Subject: Zion Station Units 1 and 2
Response to NRC Generic Request
For Information on Auxiliary Feedwater
System Flow Requirements
NRC Docket Nos. 50-295 and 50-304

NRC REQUEST FOR INFORMATION ON
BASIS FOR AUXILIARY FEEDWATER
SYSTEM FLOW REQUIREMENTS

Zion Station Units 1 and 2

Figure 3-1
Zion Auxiliary Feedwater System

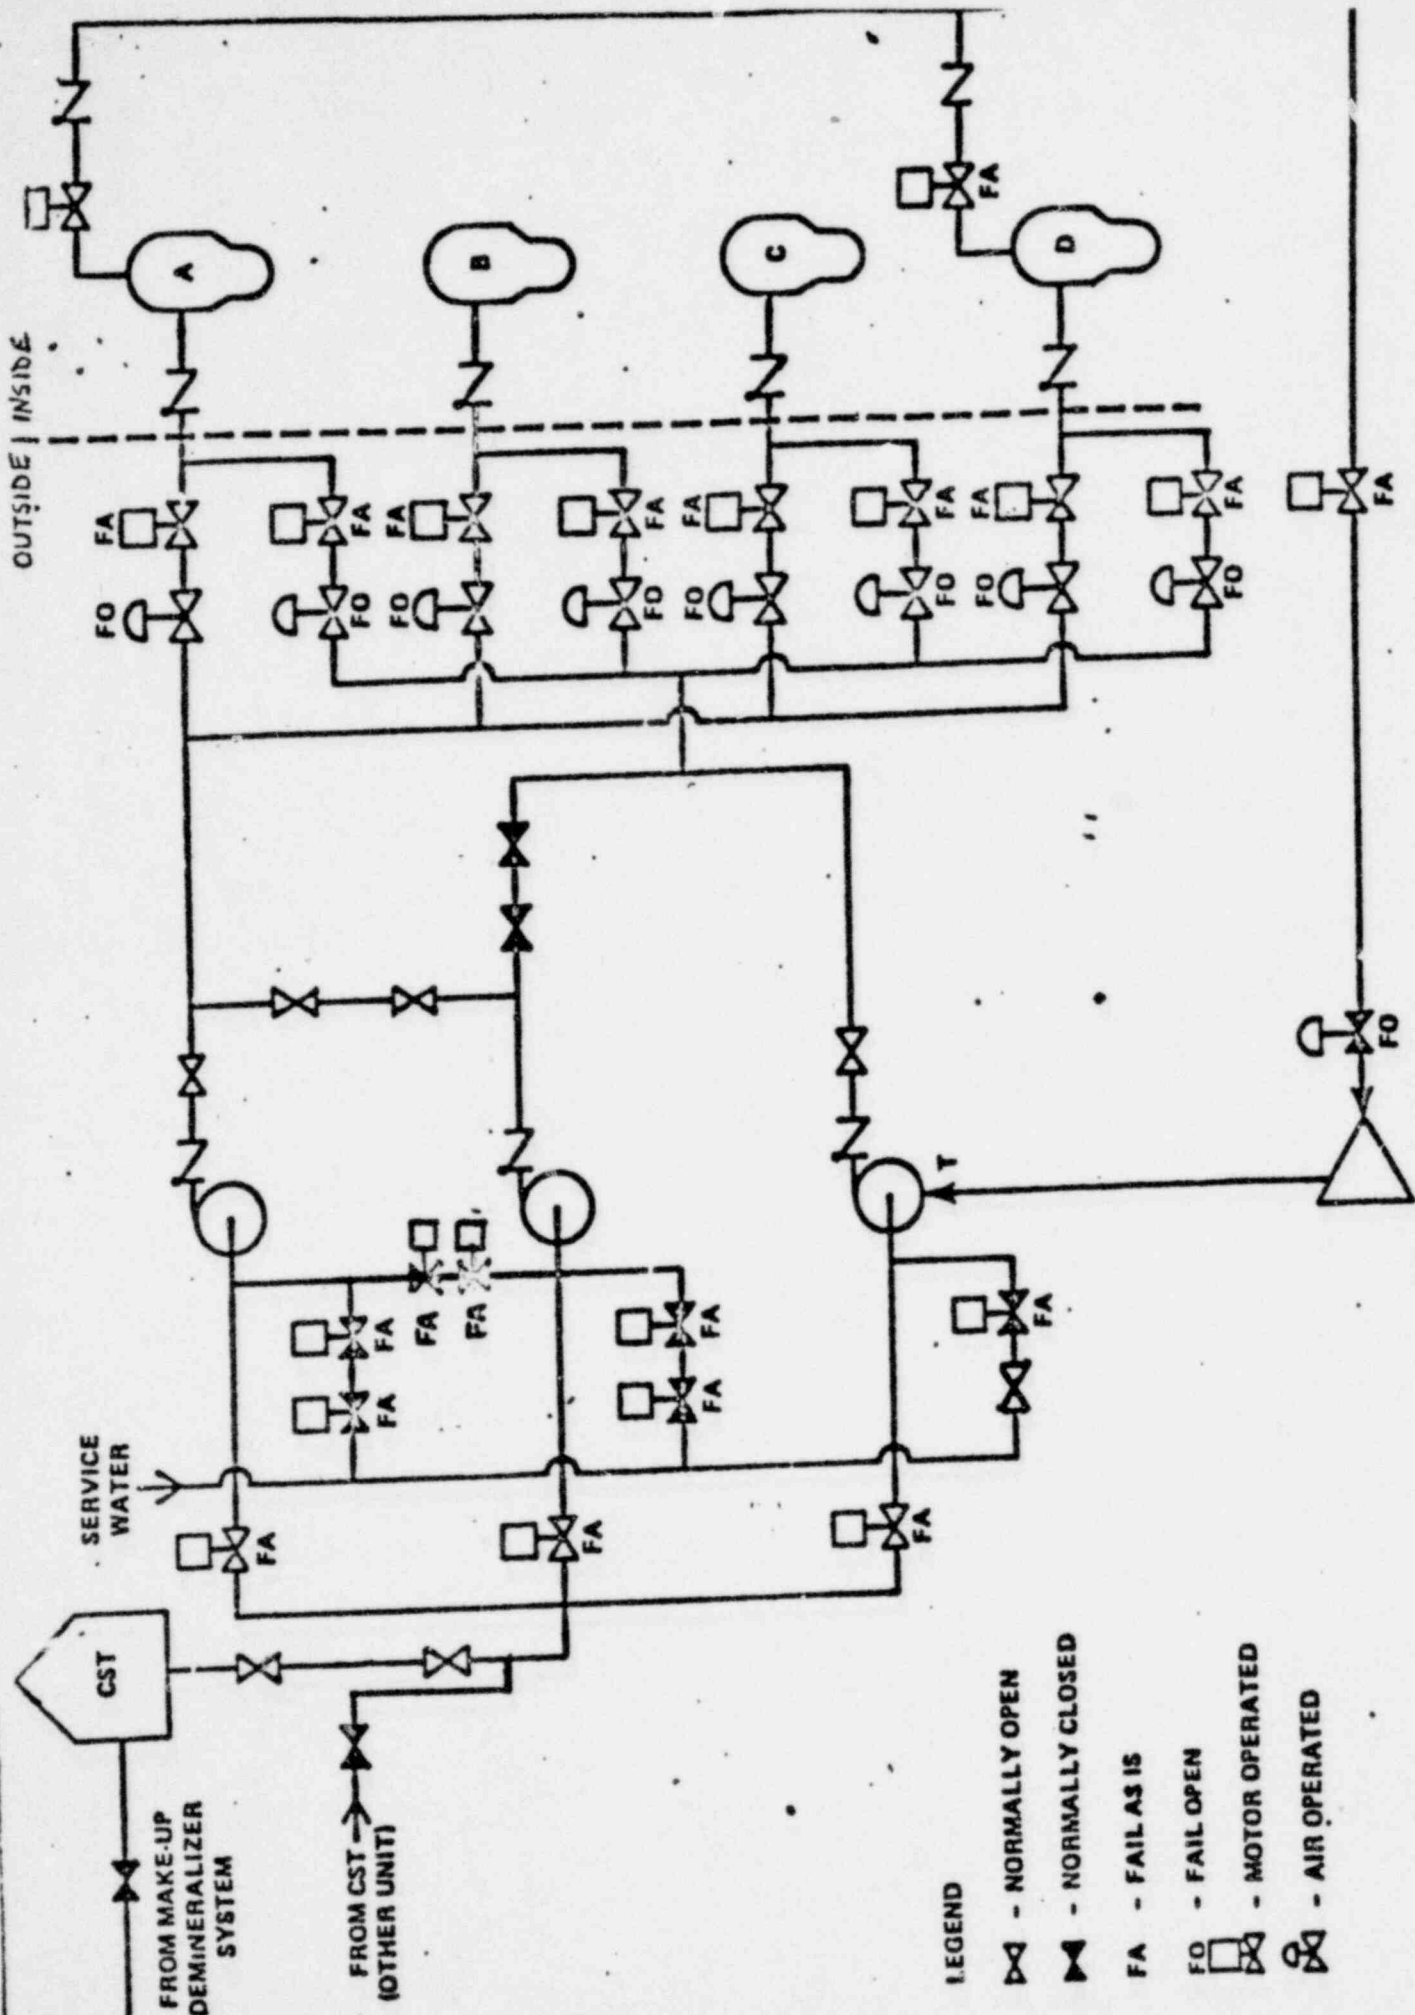
Verify that the AFW pumps in your plant will supply the necessary flow to the steam generator(s) as determined by Items 1 and 2 above considering a single failure. Identify the margin in sizing the pump flow to allow for pump recirculation flow, seal leakage, and pump wear.

Figure 3-1 schematically shows the major features and components of the Auxiliary Feedwater System for the Zion Units. Flow rates for all of the design transients described in Response 2 have been met by the system for the worst single failure. The flows for those single failures considered are tabulated for the various transients in Table 3-1, including the following:

As indicated in Table 2-1, the minimum required AFW flow rate is 420 gpm. Table 3-1 illustrates that during the analyzed transients and projected single failures there is, at minimum, 840 gpm available. Sufficient AFW flow is available in the Zion Station design.
